**AGENDA
PLANNING COMMISSION
CITY OF WYOMING, MINNESOTA
SEPTEMBER 14, 2021
7:00 PM**

TO: Planning Commission
FROM: Tom Ramler-Olson, City Planner
Fred Weck
MEETING DATE: September 14, 2021
RE: Preliminary Plat Review
APPLICANT/OWNER: Beckmann Custom Homes, LLC
PROPERTY: PID R21.00040.01, R21.00040.02, R21.00040.03,
R21.00040.04, R21.00040.05, R21.00040.06
FILE NO.: D-21-010

PRELIMINARY PLAT RE-PLAT OF DIAMOND RIDGE

DIAMOND RIDGE REPLAT - 261st STREET CUL-DE-SAC
BECKMANN CUSTOM HOMES
WYOMING, MN
DETAILS

**Figure LU-1
LAND USE PLAN
Wyoming, MN**

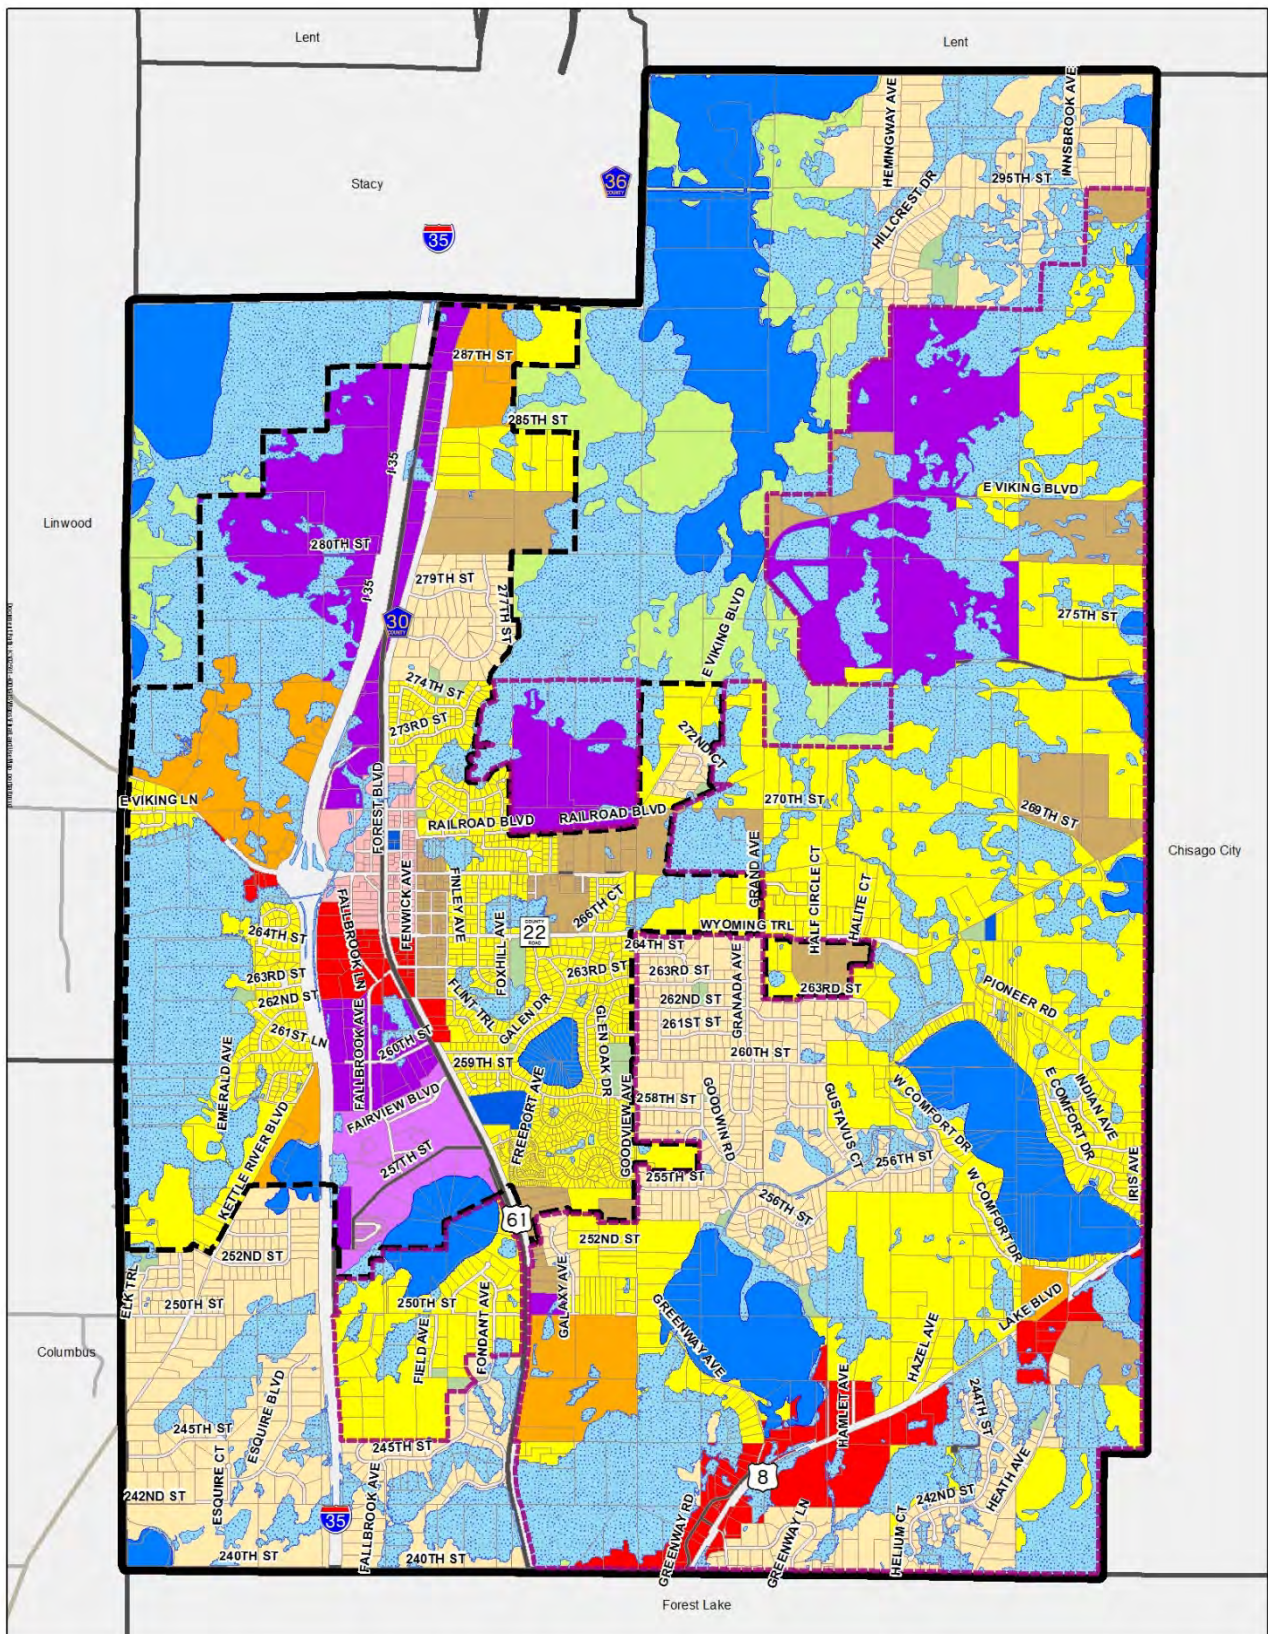
Chair Lobermeier stated that the color coding is a bit confusing and it is difficult to differentiate between some of the colors. He noted that it appears as though the entire City is under a 500 year floodplain. He stated that he thinks this does a good job of showing how little land is actually available. He stated that the Land Use map still needs to be reviewed and a decision made on whether the Commission is still comfortable with it and whether it is still valid. He stated that for the next meeting, the Commission needs to digest and decide if this map is what they want it to be for the Comprehensive Plan.
